Technical Service Bulletin: TSB250166

TRP #5818 C500D6RE Cooling Package Assembly Replacement

Figure 3, Old-Style Failed Bellow

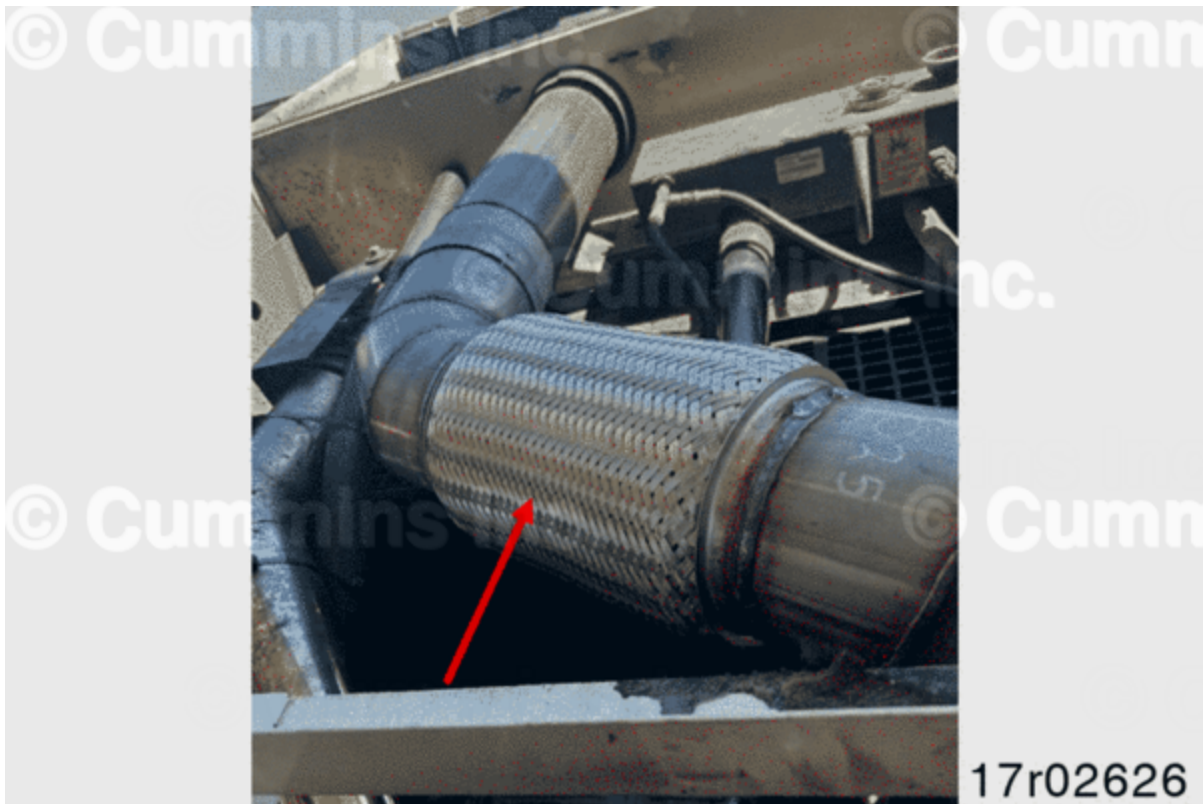
Note: A revised exhaust bellow kit has also been released. If the unit experiencing radiator failure has the old-style bellow pictured below in right of Figure 3, the revised bellow kit, should also be ordered and replaced at the time of radiator package replacement. See Service Parts Availability section for part ordering information.

For units experiencing radiator core failure, a revised bar and plate service cooling package assembly (Radiator), Part Number, A079N739 and Mounting Conversion Kit, Part Number, A079G753 have been released.
